# Flood Impact Assessment

Proposed Aged Care Facility at Bulli

Prepared for  
Anglicare

## 2 Response to Wollongong City Council RFIs

Figure 6-1      Drainage Concept Plan

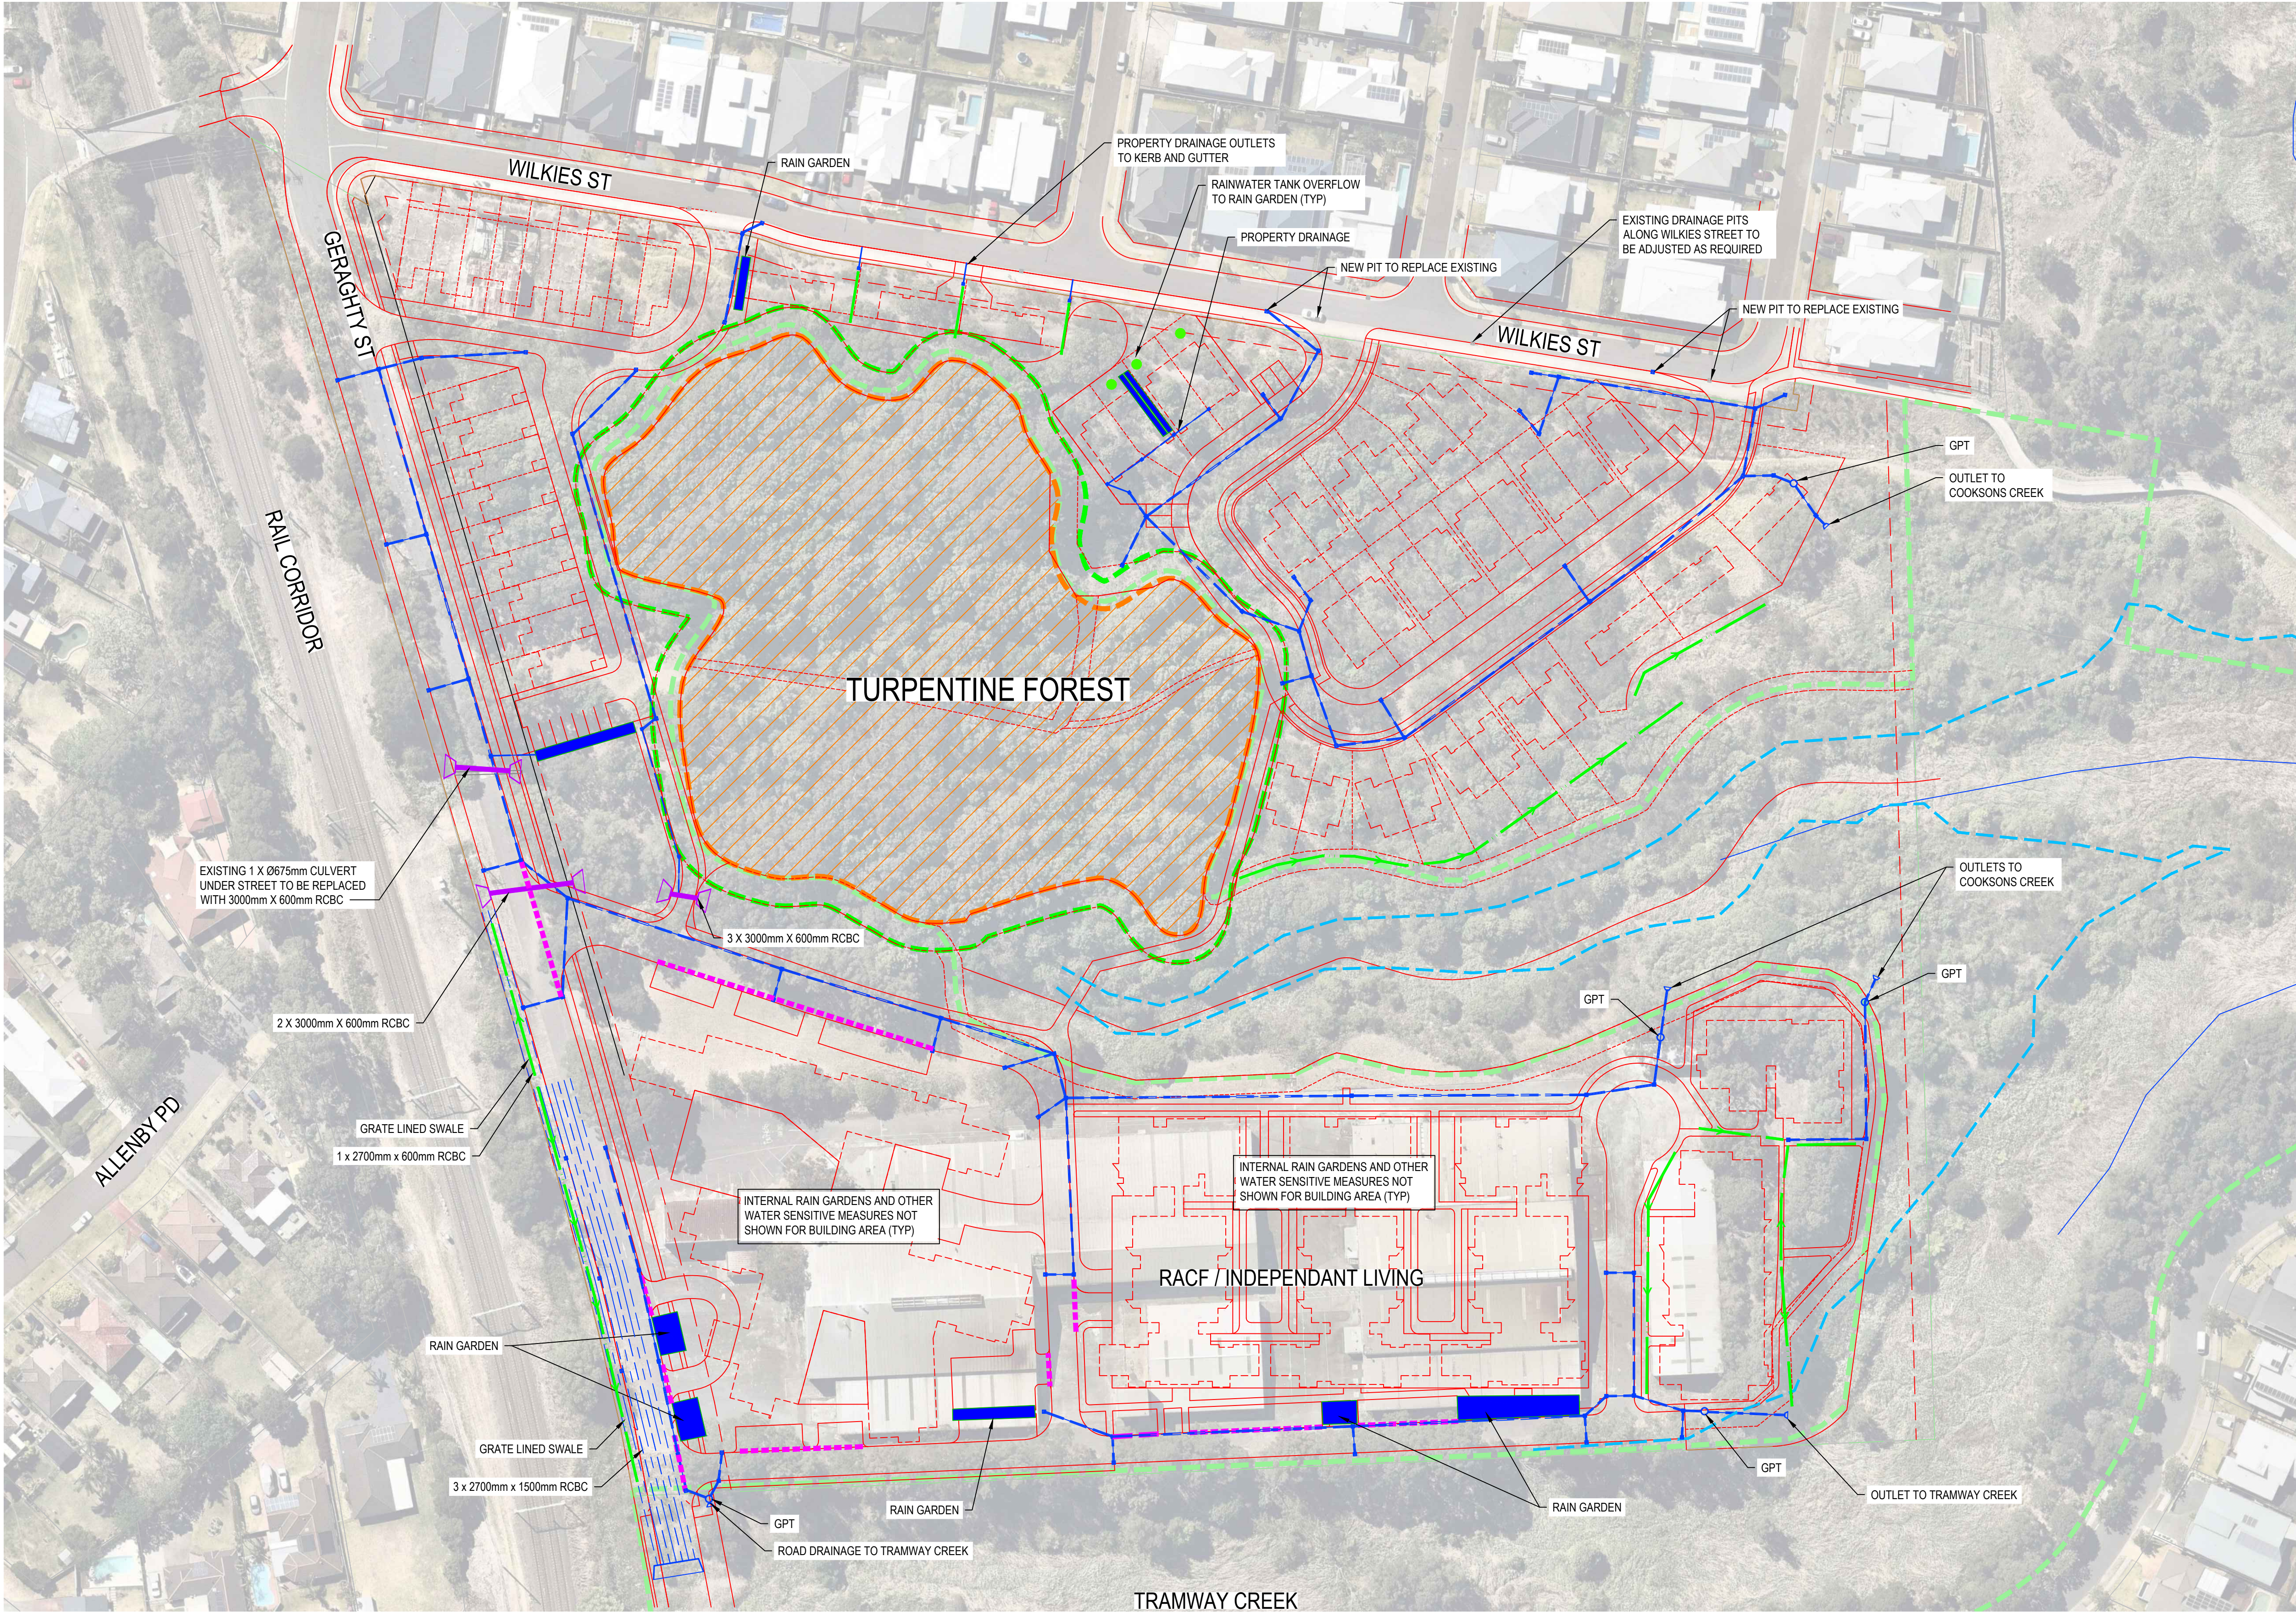
Previous RFI Comments (18 December 2018)	WCC Current Comments	Response
<b>Stormwater</b>		
<p>The following matters have not been addressed:</p> <ul style="list-style-type: none"> <li>The proposed concept layout requires filling and re-aligning of an existing watercourse channel and culvert (i.e. upper portion of Cookson's Creek) to facilitate the southern-most four units of the Hilltop Precinct.</li> <li>This proposal is contrary to Section 10.3.7 of Chapter E14.</li> <li>Also, the proposal to re-align a watercourse/culvert/overflow path with a near 90 degree bend is considered contrary to good floodplain management practice.</li> <li>These four units need to be removed from the proposal in order to maintain the existing watercourse and negate the need for any watercourse filling/realignment</li> </ul>	<p><u>WCC Comment:</u> The 4 dwellings previously proposed over the alignment of this watercourse have been removed from the proposal. However, the cut/fill plan by Cardno still indicates filling over the alignment of this existing watercourse, and the landscape concept plan indicates an 'ornamental lawn' over the location of the existing watercourse channel. The design needs to be amended to maintain the watercourse channel through this location. A culvert will need to be provided beneath the proposed road to maintain flows in the watercourse.</p> 	<p>The design has been updated to remove fill in this area in order to maintain the watercourse alignment (refer updated concept bulk earthworks plan 82018138-001-SK010 in <b>Appendix F</b>).</p> <p>A 3x 3000 x 1500 RCBC is proposed underneath the road to maintain the watercourse alignment and provides 100 year ARI immunity on the road (refer updated concept stormwater plan 82018138-001-SK009 in <b>Figure 6-1</b>).</p>

- > Updating the existing pipe under the Geraghty Street to suit the road development and incorporate a new culvert to discharge into Cookson Creek within the site in a location to the south of the existing discharge point. Refer to **Figure 6-1** for more details on the culverts modifications arrangement).

The internal site drainage discharges mainly to the two basins which outlet to Cookson's Creek. Geraghty Street, Western residences, and the lower southern portion of for the RACF independent living area discharges to Tramway Creek. A small portion of the proposed residences along the northwest corner of the property discharge to Wilkies Street and outlet to the kerb and gutter. **Figure 6-1** illustrates the stormwater drainage arrangement.
